Memo

SLP REV. 1 to SLP REV. 2

Date: April 25, 2016 **UBC Gage South** Re:

GAGE SOUTH EXCHANGE PHASE 1 - UNDERGROUND WORKS

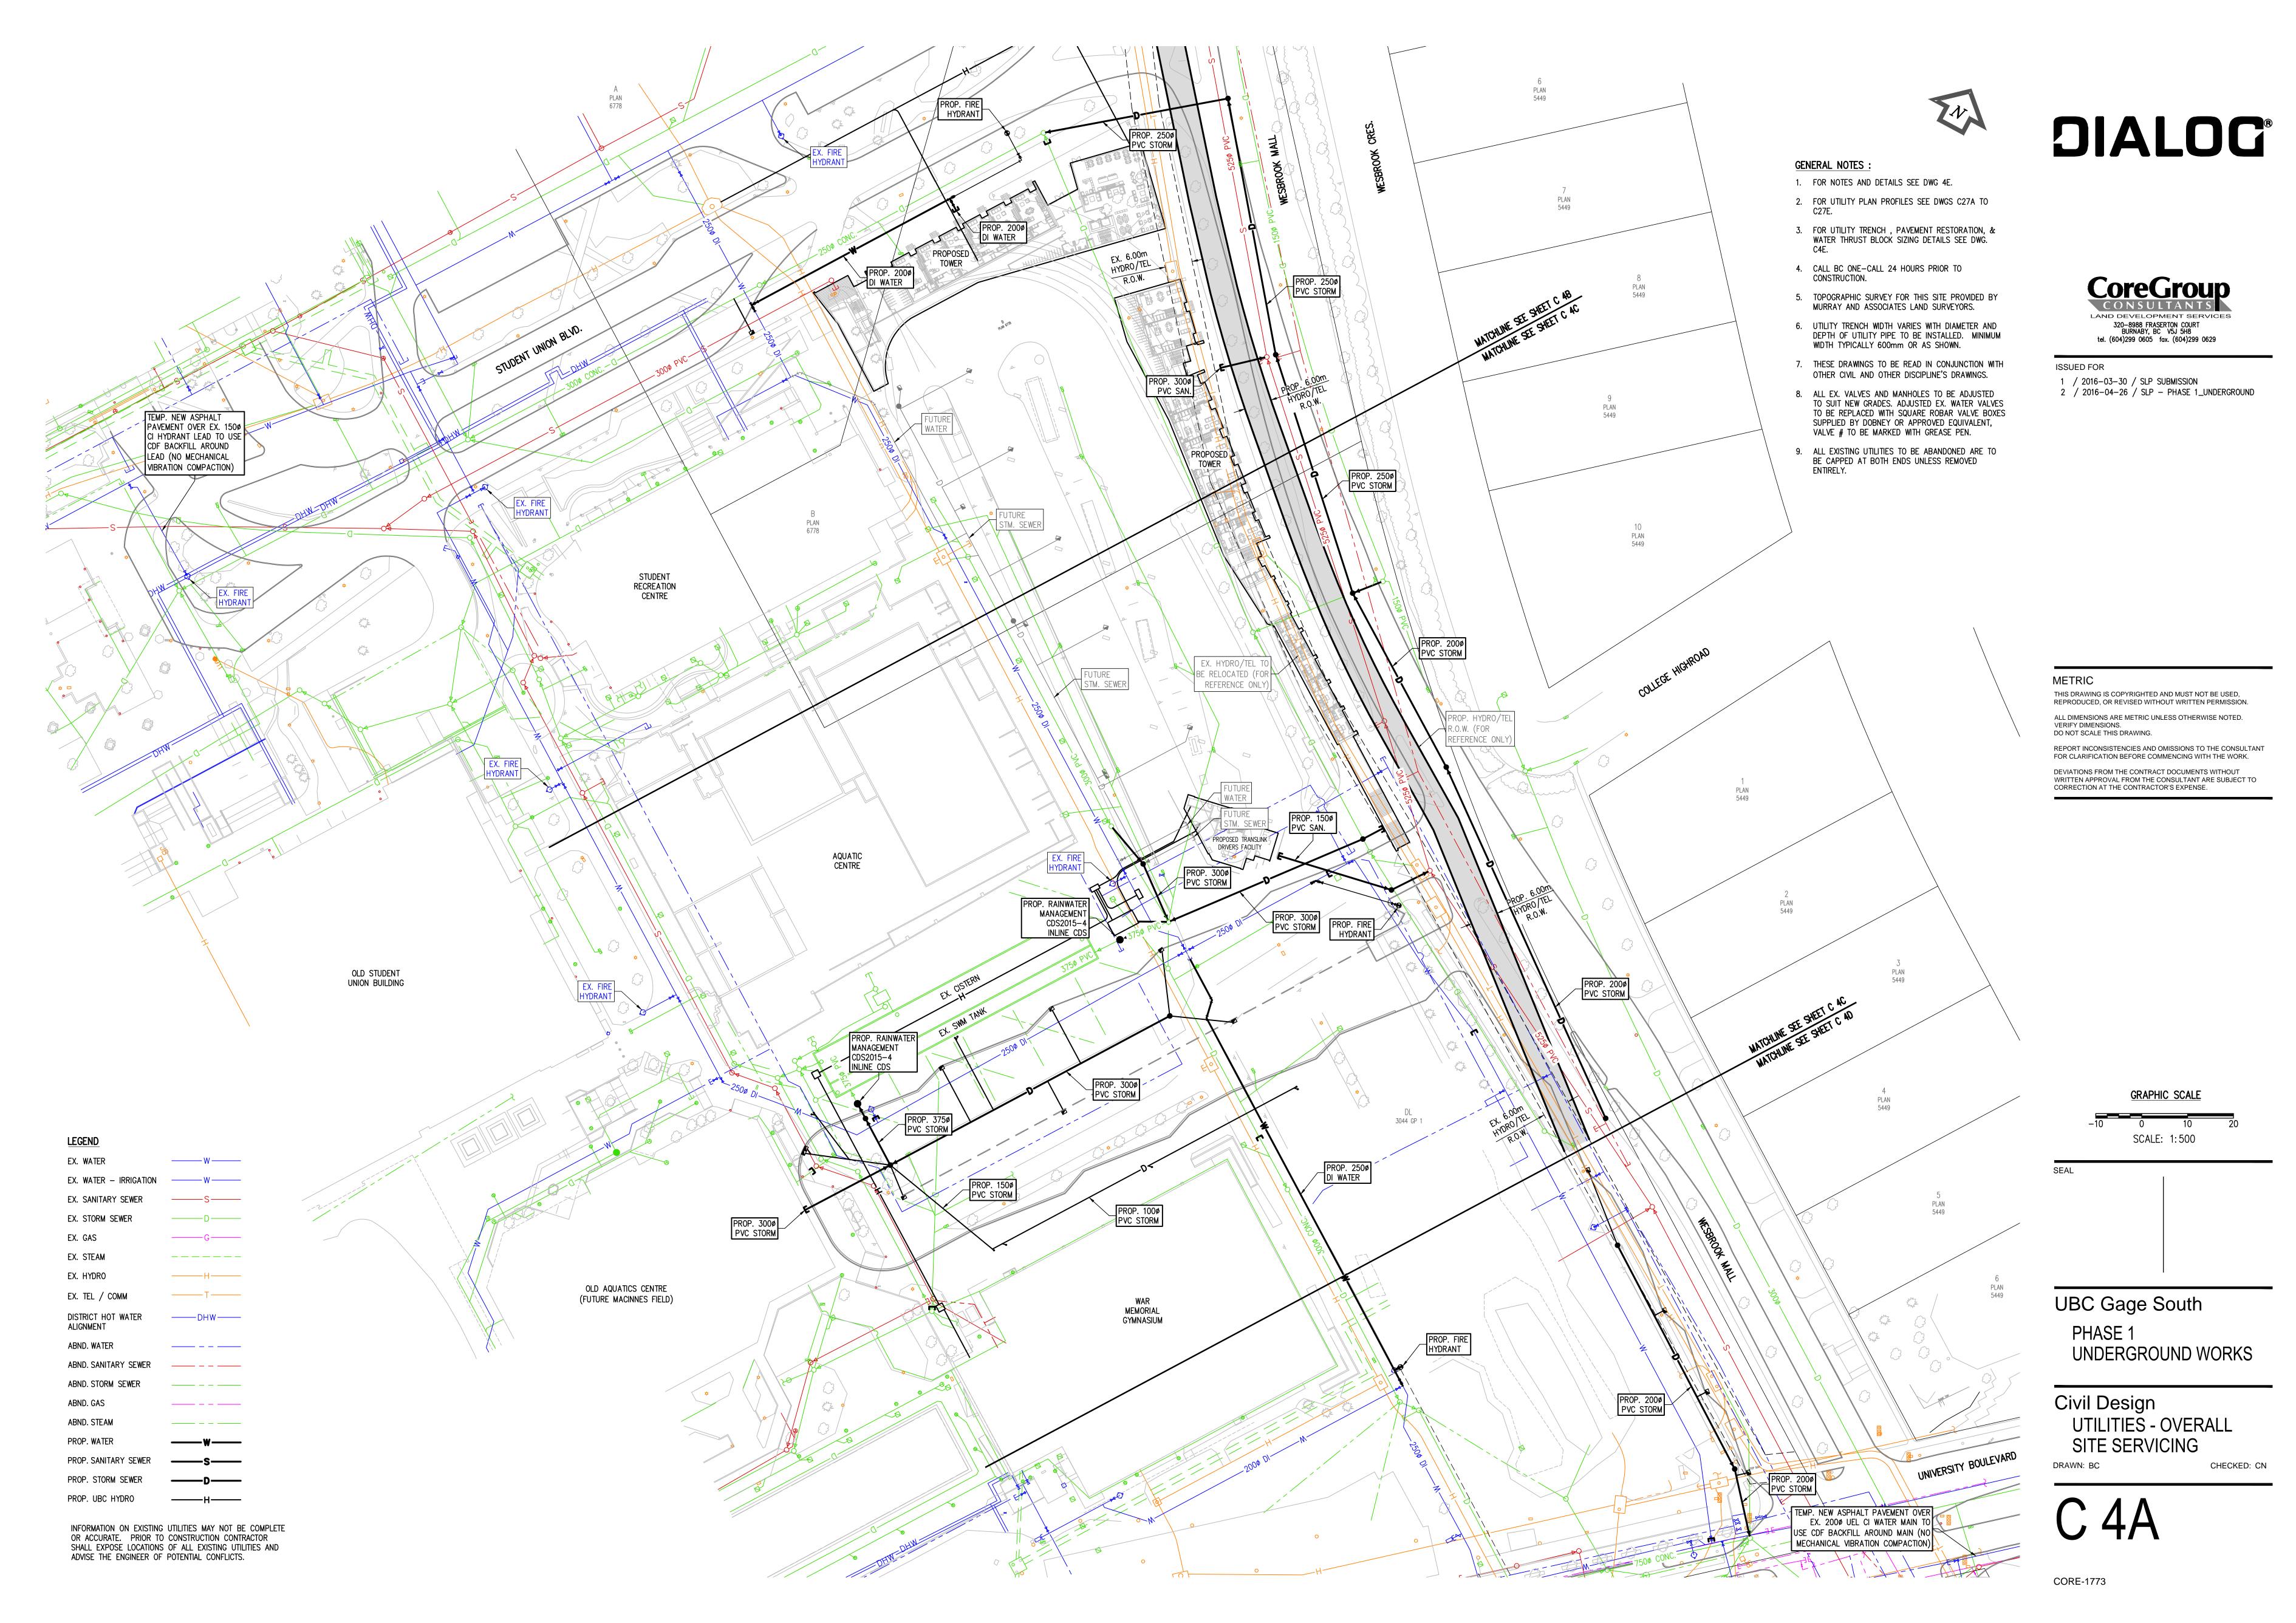
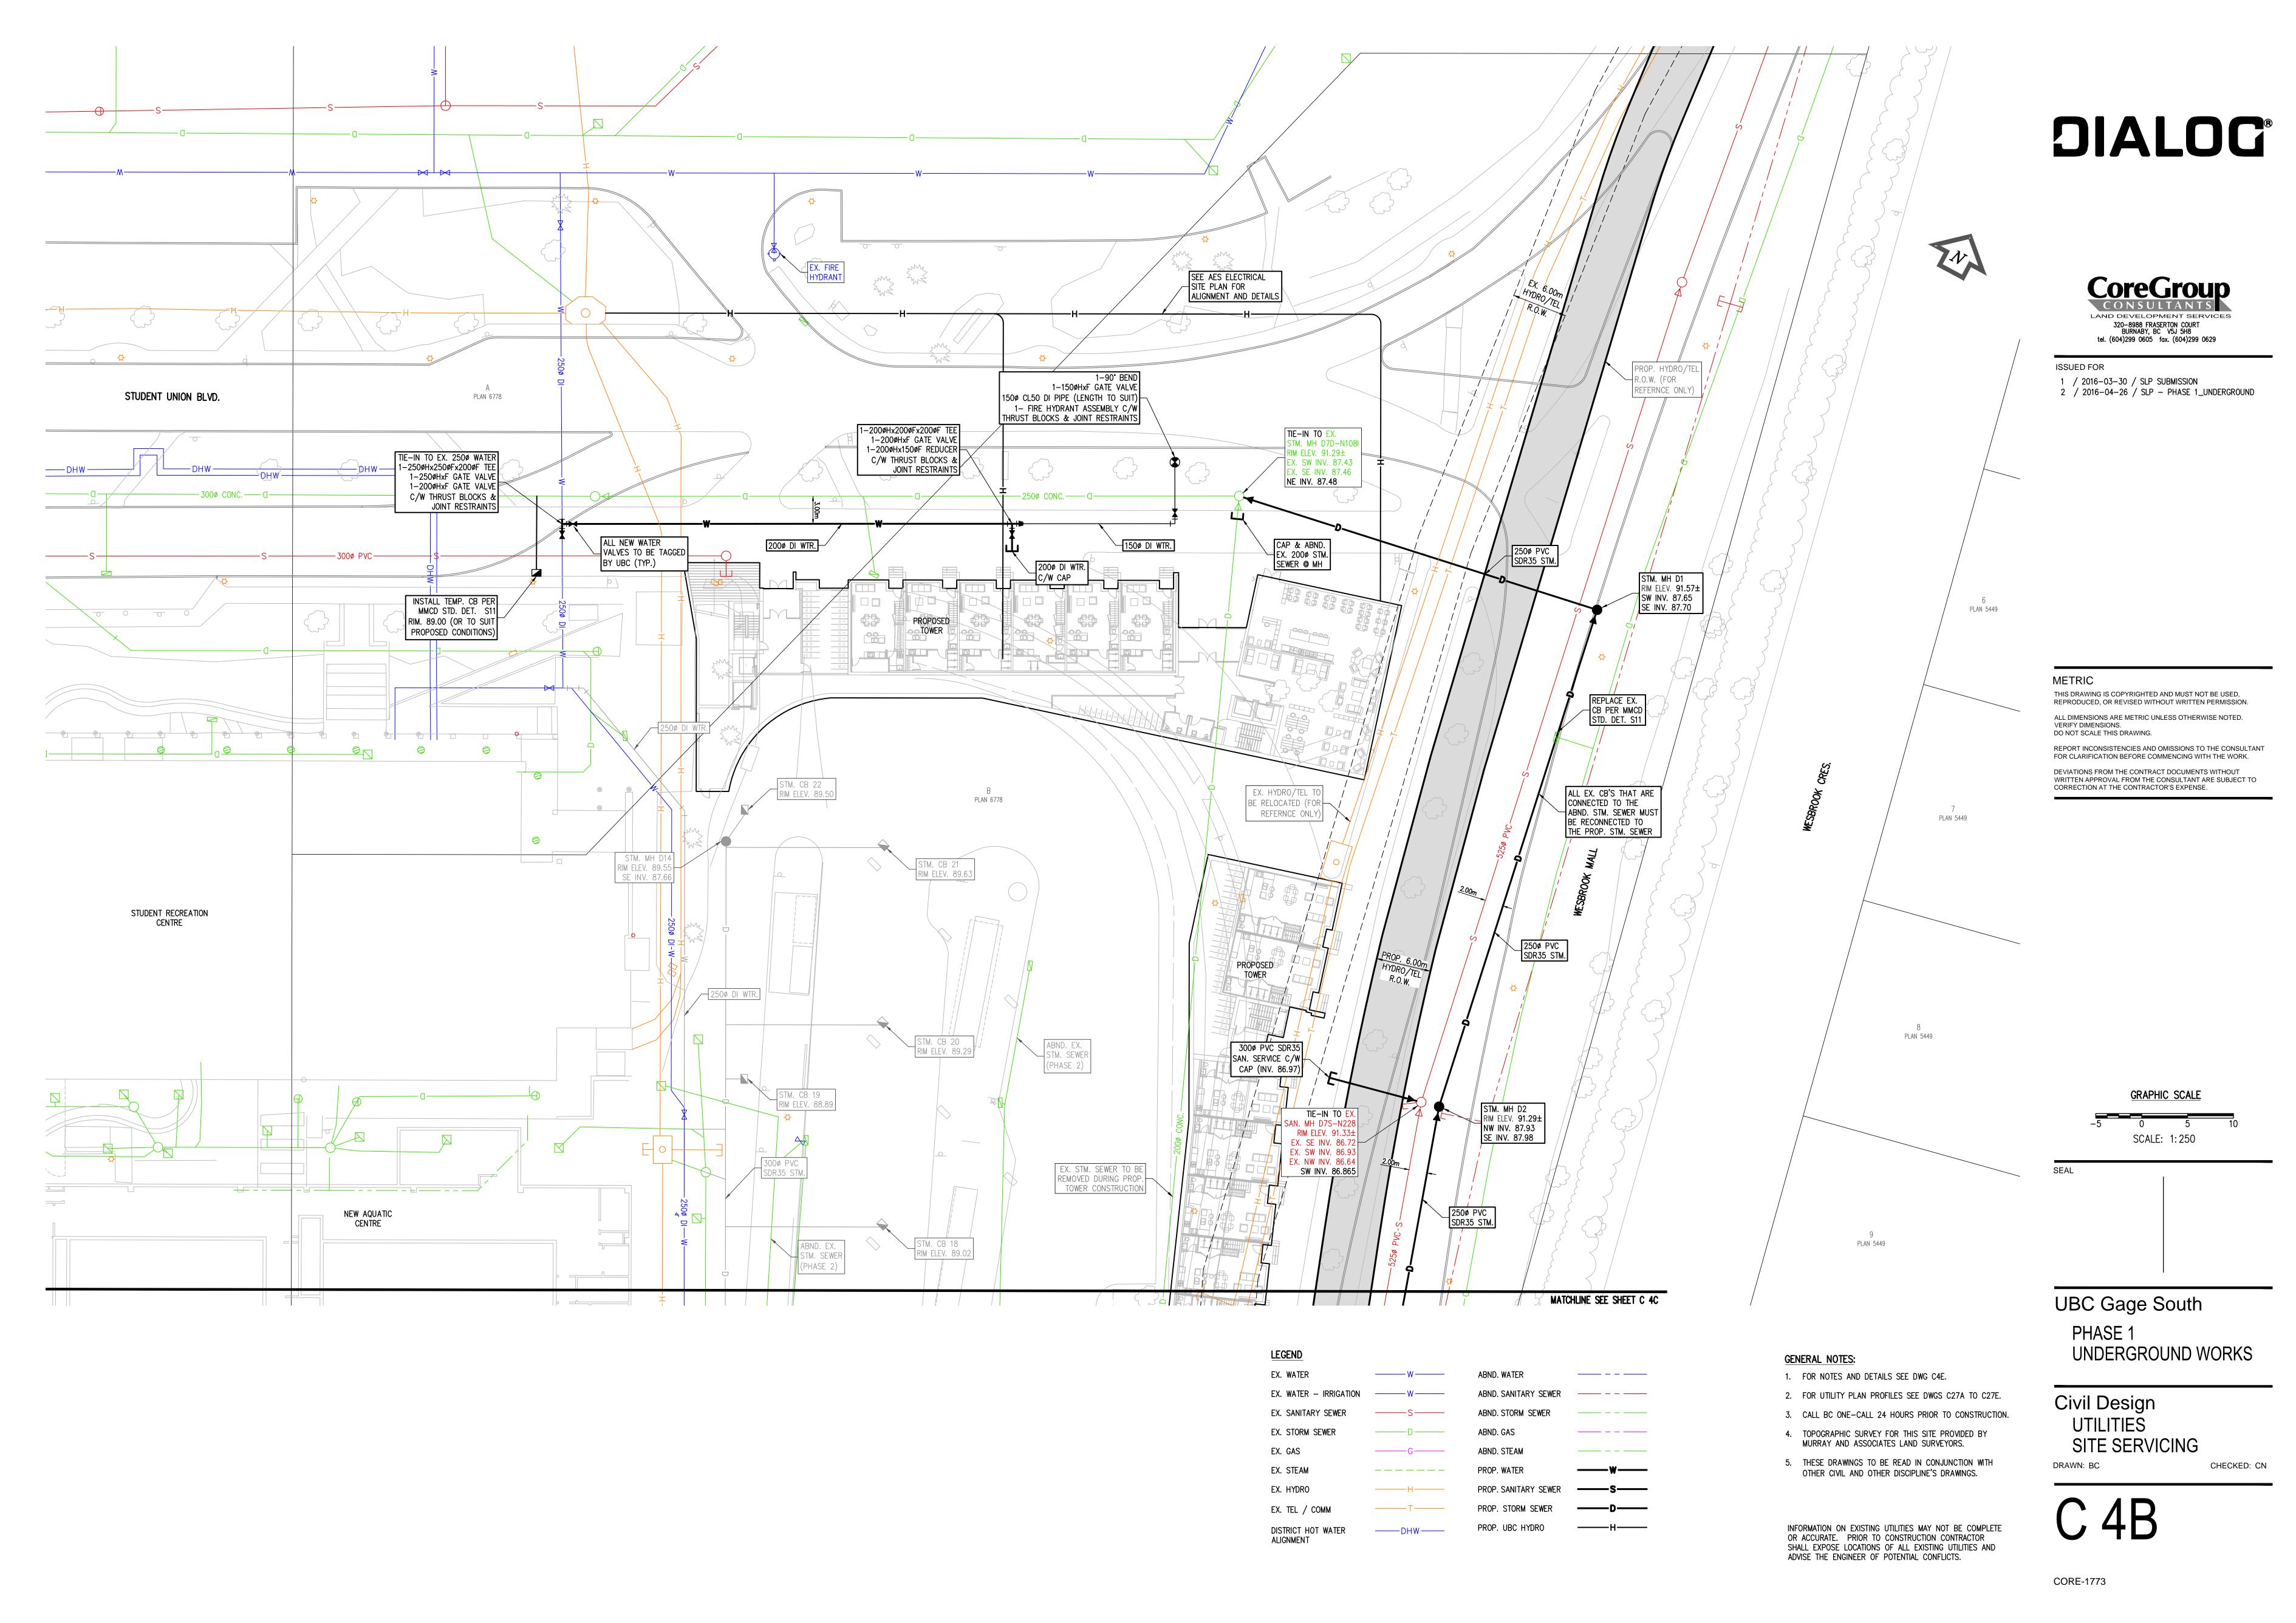
C4A - Utilities, Overall Site Servicing

- Water Connection and Hydrant Location Adjusted
- 2) Oil/TSS Removal Manhole Revised
- 3) Hydrant Removed
